## PRODUCT/PROCESS CHANGE NOTICE (PCN)

PCN #: **TB0711-01** DATE: **12/06/2007**

Product Affected: **950 mils x 950 mils PQFP 132L**  
**shipped in tray**

### ATTACHMENT I - PCN #: TB0711-01

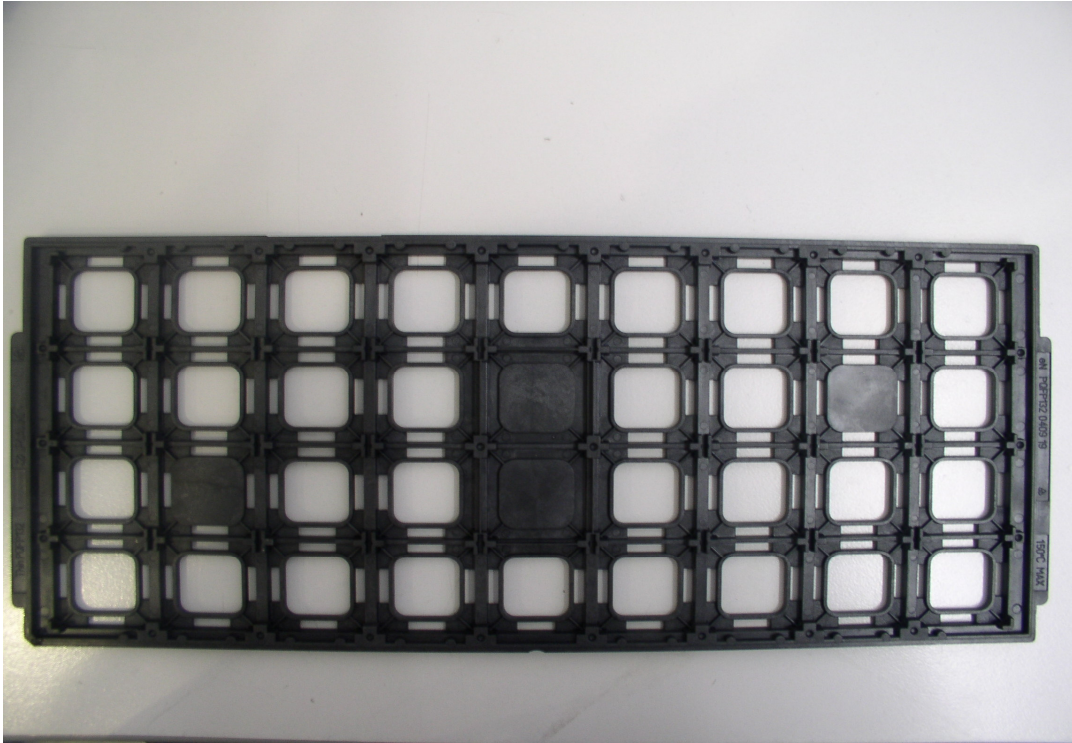
**Detail of Change:** This notification is to advise our customers that IDT has qualified new shipping trays for 950 mils x 950 mils PQFP 132L products.

There is no change to the number of units per tray and tray dimensions but changes to the tray withstand temperature.

Description	Existing Shipping Tray	New Shipping Tray
Supplier	E-Pak	NK Tech
Supplier Part Number	eN PQFP 132 0409 19	TMHT-040901-01
IDT Part Number	P7-210-000	P7-227-000
Tray Matrix	4 X 9	4 X 9
Qty per Tray	36 units	36 units
Rating Temperature	150°C	135°C
Tray Material	MPPO	PPE + CF
Pocket Size (WxL)	27.84 X 27.84 +/- 0.13 mm	28.09 X 28.09 +/- 0.13 mm
Tray Drawing Number	MSC-5706	MSC-5755

TOLERANCES UNLESS OTHERWISE SPECIFIED		DECIMAL		ANGLE	
XX ±.25		XX ±.13		XX ±.5°	
XX ±.13		XX ±.13		XX ±.13	
APPROVALS		DATE		SCALE	
DRAWN		DATE		N/A	
CHECKED		DATE		B	
TITLE: PQ/PQG 132 SHIPPING TRAY		STOCK NO. P7-210-000		DRAWING NO. MSC-5706	
DO NOT SCALE DRAWING		SHEET 2 OF 2		REV 00

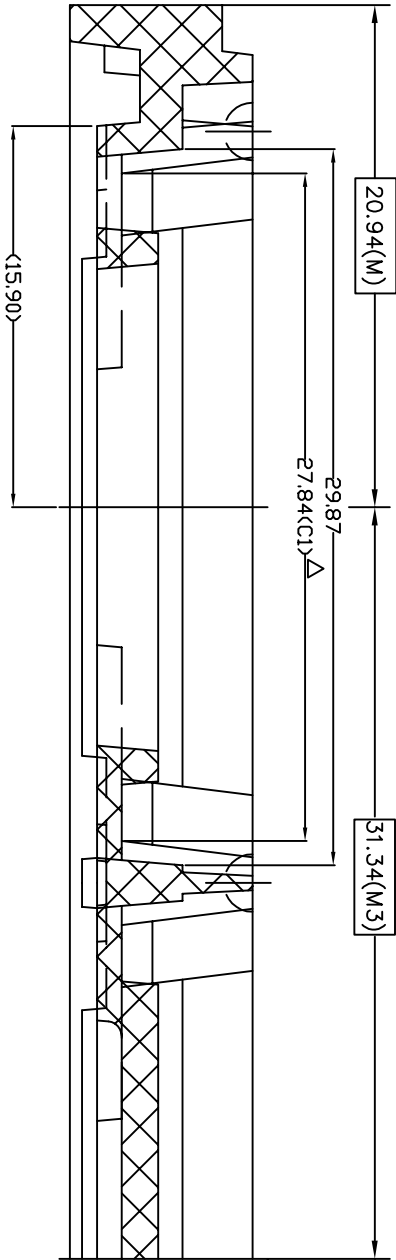
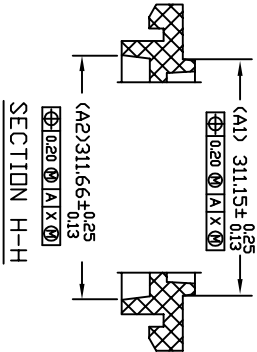
Attachment III provides the existing and new tray drawings.
